APPLICATION FOR A RESIDENTIAL SITE IMPROVEMENT PERMIT/ CONSTRUCTION AUTHORIZATION FOR AN ON-SITE WASTEWATER SYSTEM, NEW WELL INSTALLATION, OR REPAIR OF EXISTING WELL

Re: Application for improvement permit for: 4 Bedroom House
Property Location: 12609 Wildlife Ln, Huntersville, NC 28078
Health Department File Number: **11310B (App ID 12891)**

SOIL/SITE EVALUATION
for ON-SITE WASTEWATER SYSTEM

PROPOSED PLOT PLAN

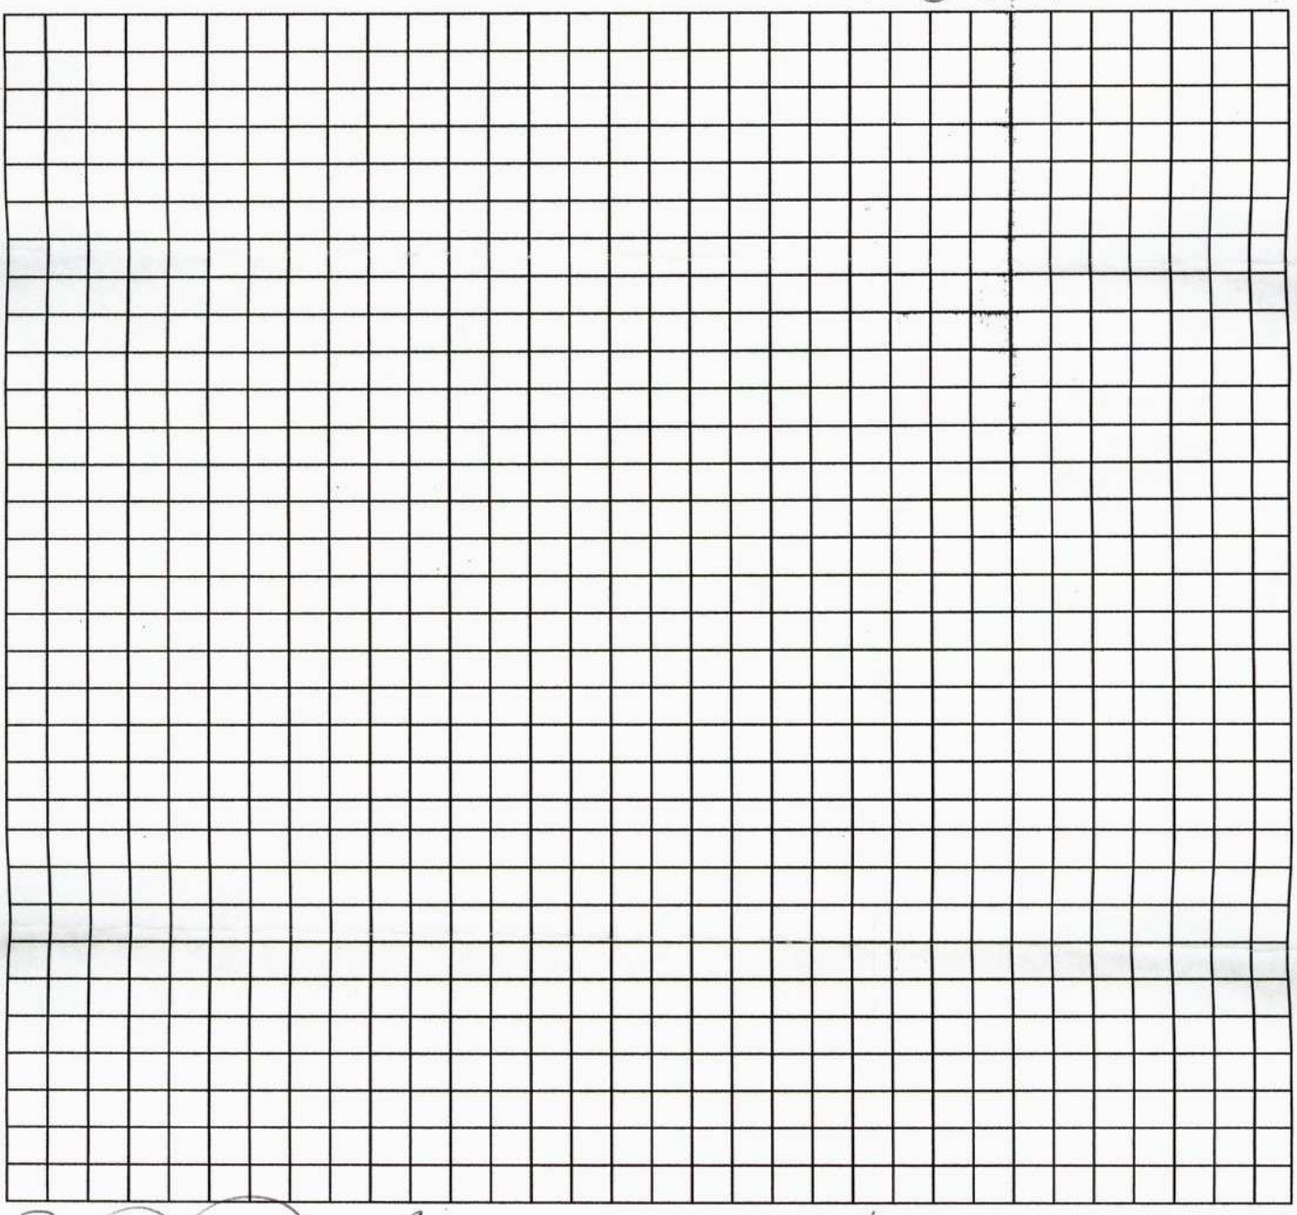
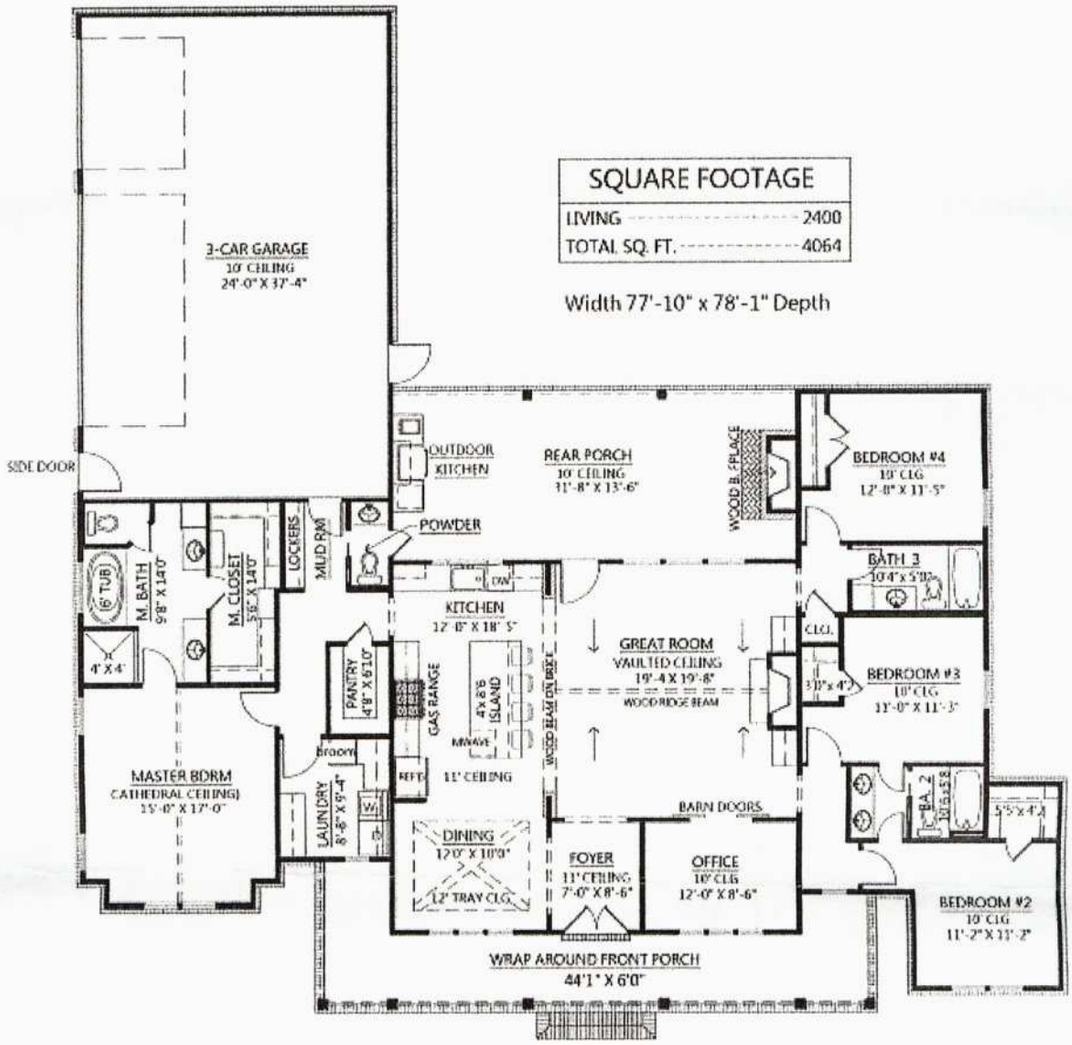
The Mecklenburg County Health Department, Environmental Health Division on March 11, 2022 evaluated the above-referenced property at the site designated on the site plan that accompanied your improvement permit application. According to the application the site is to serve a 4 Bedroom Residence, with a daily design flow of 480 gallons per day. The evaluation was done in accordance with the laws and rules governing wastewater systems in North Carolina General Statute 130A-333 and related statutes and Title 15A, Subchapter 18A, of the North Carolina Administrative Code, Rule .l900 and related rules.

Based on the criteria set out in Title 15A, Subchapter 18A, of the North Carolina Administrative Code, Rules .1940 through .1948, the evaluation indicated that the site is **UNSUITABLE** for a ground absorption sewage system. Therefore, your request for an improvement permit is **DENIED.** A copy of the site evaluation is enclosed. The site is unsuitable based on the following:

- ☒ Unsuitable soil topography and/or landscape position (Rule .1940)
- ☒ Unsuitable soil characteristics (structure or clay mineralogy) (Rule .1941)
- ☒ Unsuitable soil wetness condition (Rule .1942)
- ☒ Unsuitable soil depth (Rule .1943)
- ☐ Presence of restrictive horizon (Rule .1944)
- ☒ Insufficient space for septic system and repair area (Rule .1945)
- ☒ Unsuitable for meeting required setbacks (Rule .1950)
- ☐ Other (Rule .1946)

The site evaluation included consideration of possible site modifications, and modified, innovative or alternative systems. However, the Health Department has determined that none of the above options will overcome the severe conditions on this site. A possible option might be a system designed to dispose of sewage to another area of suitable soil or off-site to additional property.

However, the site classified as **UNSUITABLE** may be classified as **PROVISIONALLY SUITABLE** if written documentation is provided that meets the requirements of Rule .1948(d). A copy of this rule is enclosed. You may hire a consultant to assist you if you wish to try to develop a plan under which your site could be reclassified as **PROVISIONALLY SUITABLE.**
